City of Sumner **DESIGN COMMISSION**

AGENDA
Wednesday, February
21, 2024
6:30 p.m.

**a) 15403/15407 Main
Street**

DR-2023-0015 – Design Review for a
new commercial building to replace
one lost to a fire. Development
includes new 16,200sf building and
site improvements to .13 acre site.

Seawest Main St. Development - Driveway Modification Request

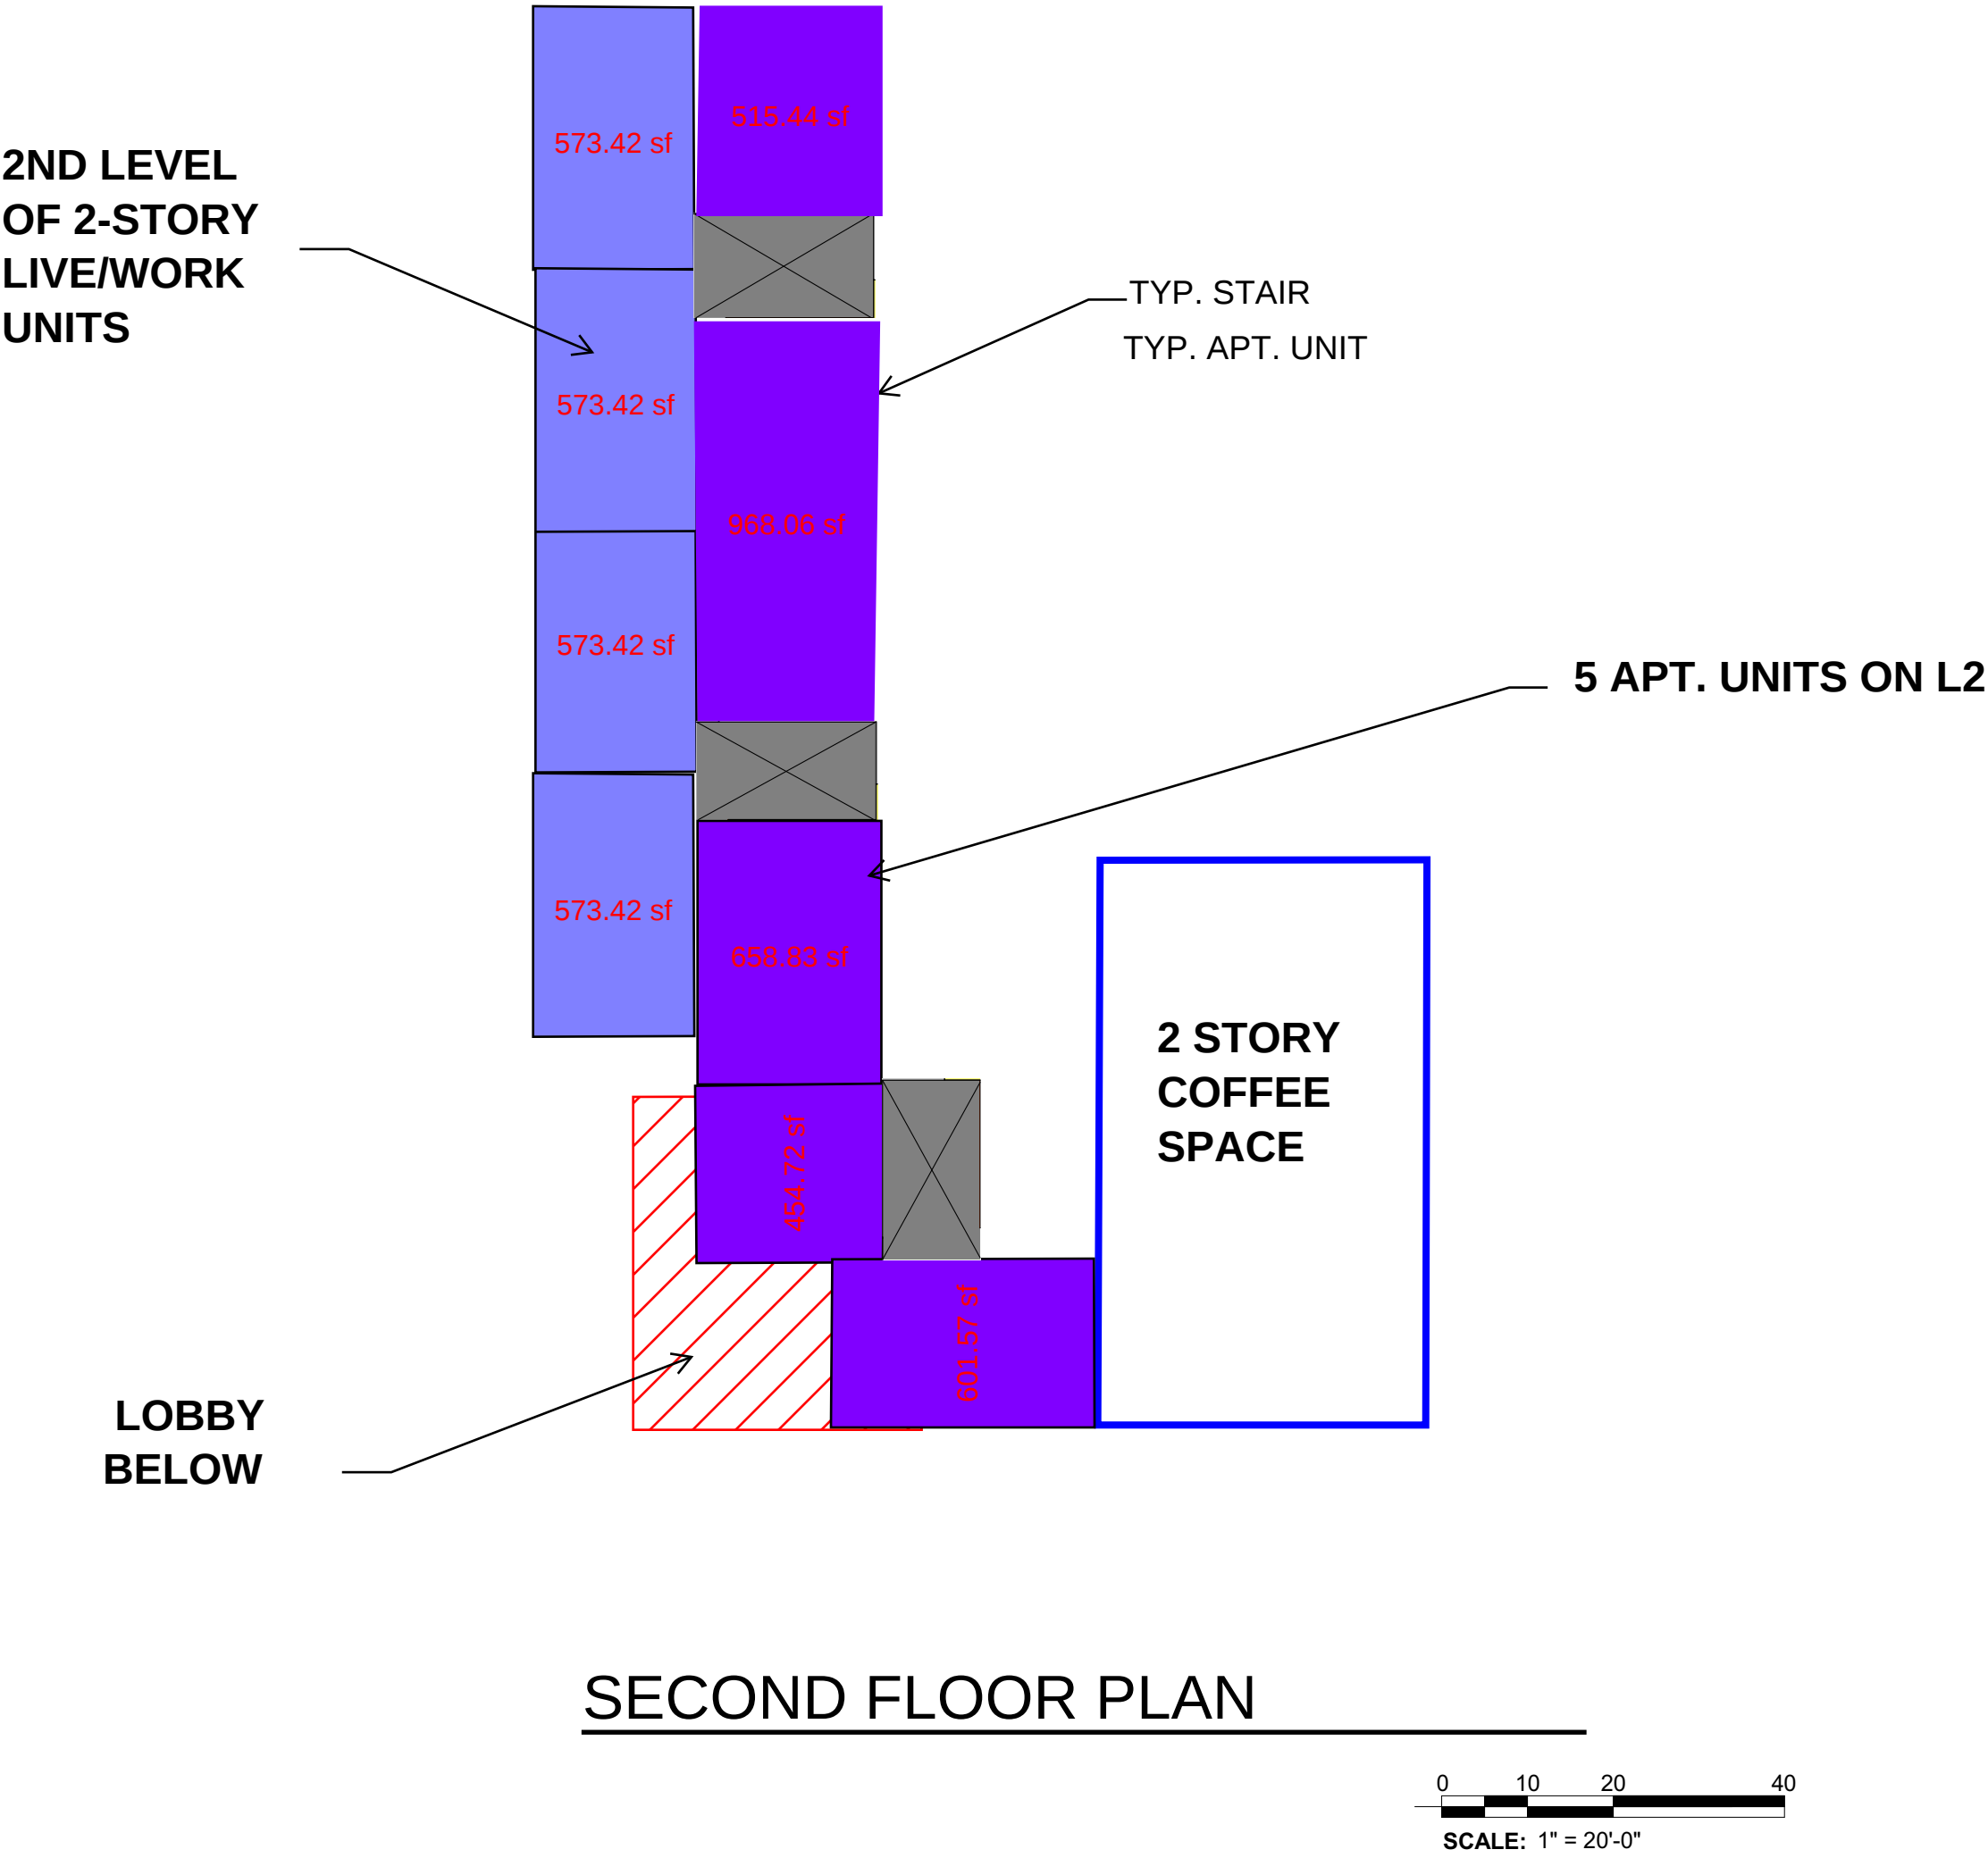
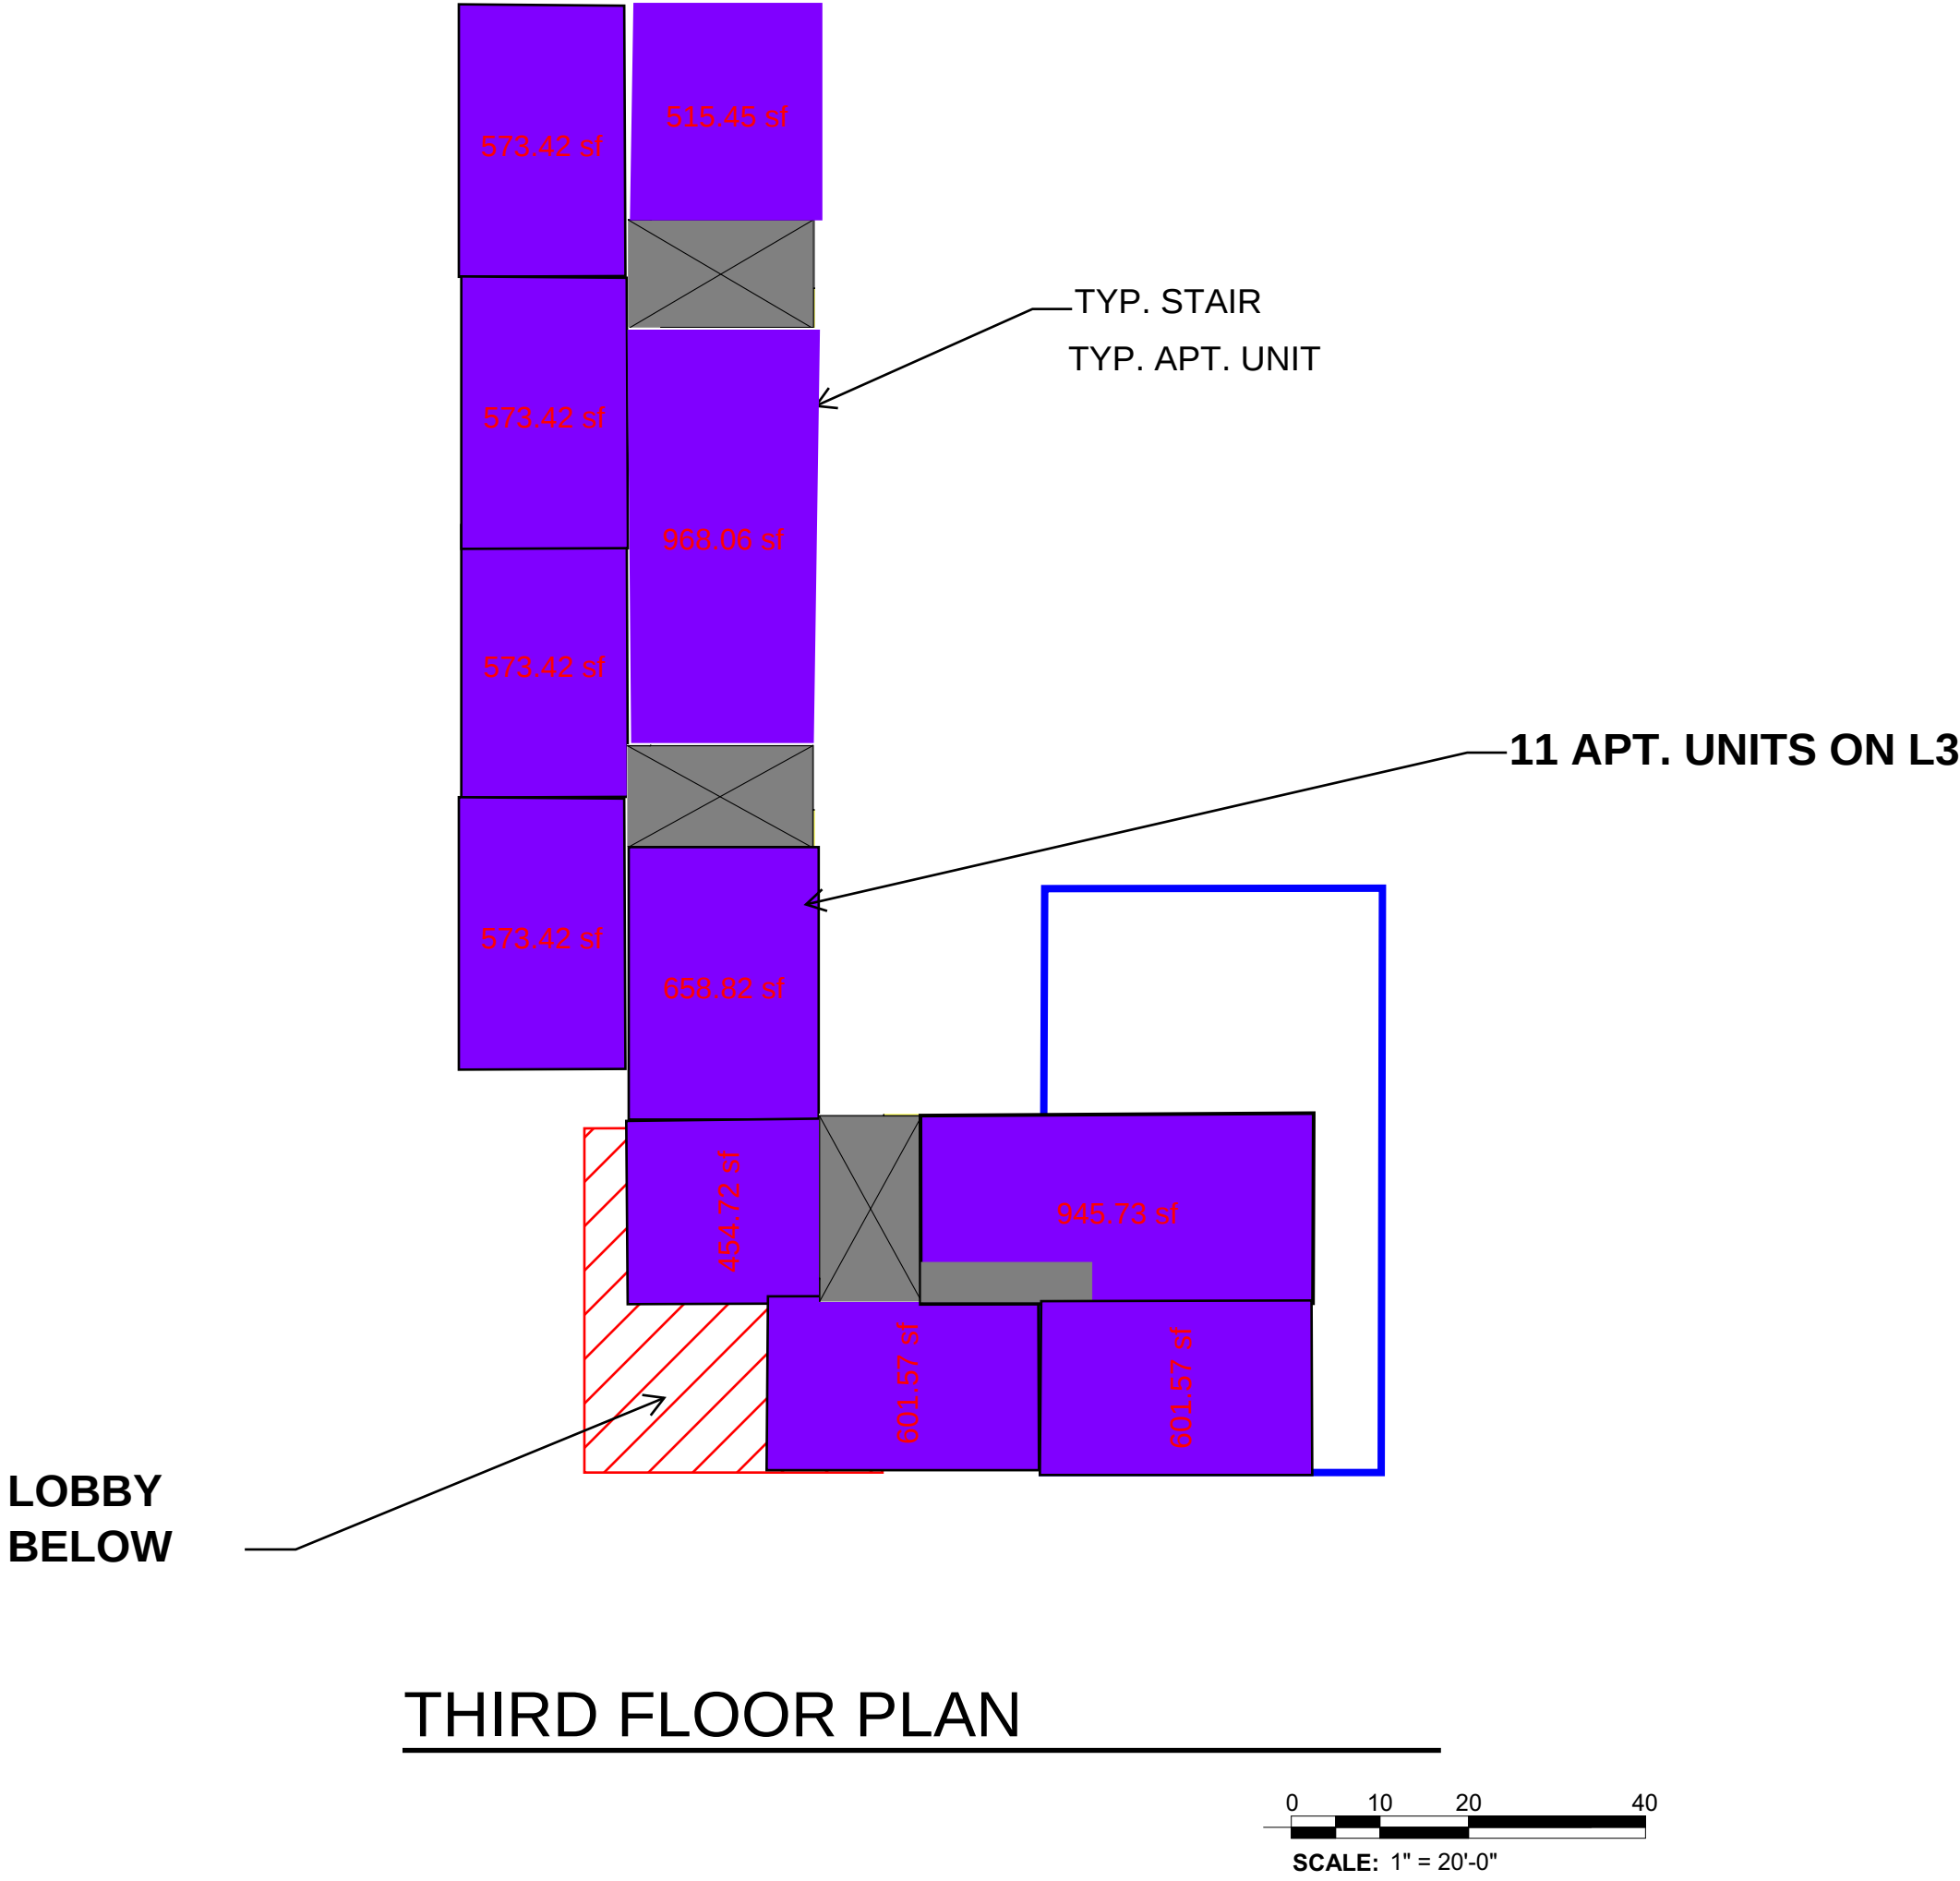
This scope of review and recommendation for the Design Commission is through the Modified Approvals under SMC 18.43.140 and not on the actual proposed developments design and only relates to this projects ability to include a drive through lane onto Main Street. During further Design Review for the site, the project will need to show compliance with all codes and Design Guidelines. This would require changes to the included site plan to ensure compliance with drive through performance standards, parking requirements and all other codes and guidelines. The current site plan configuration doesn't comply with the drive through standards in SMC 18.16.080(R)(1) and the site is below the minimum parking requirements in SMC 18.42.

The proposed driveway modification to SMC 18.43 (PLN-2024-0003) should not be approved. Staff does not support the proposed drive through onto Main Street as currently shown and does not recommend a modification to SMC 18.43.

1. The exact driveway location and configuration is not approved and subject to change at time of development, based on City review of specific driveway design and details needed to safely connect to Main Street.

2. The allowance for a driveway on this site does not guarantee the site configuration shown, but rather allows a driveway to be included as part of an approvable plan. Future development will be required to meet the Sumner Design Guidelines and all other applicable codes, including compliance with SMC 18.16.080 (R) for any proposed drive through.

3. The driveway crossing at East Main must include a contrasting paving material and design from adjacent sidewalks in order to provide a safe and distinguished pedestrian crossing over the driveway approach and include signage and safety measures determined by City Engineering.

4. Project frontage including types and locations of landscaping and street parking stalls shall show safe circulation, sightlines and safety measures between sidewalk users and the driveway.
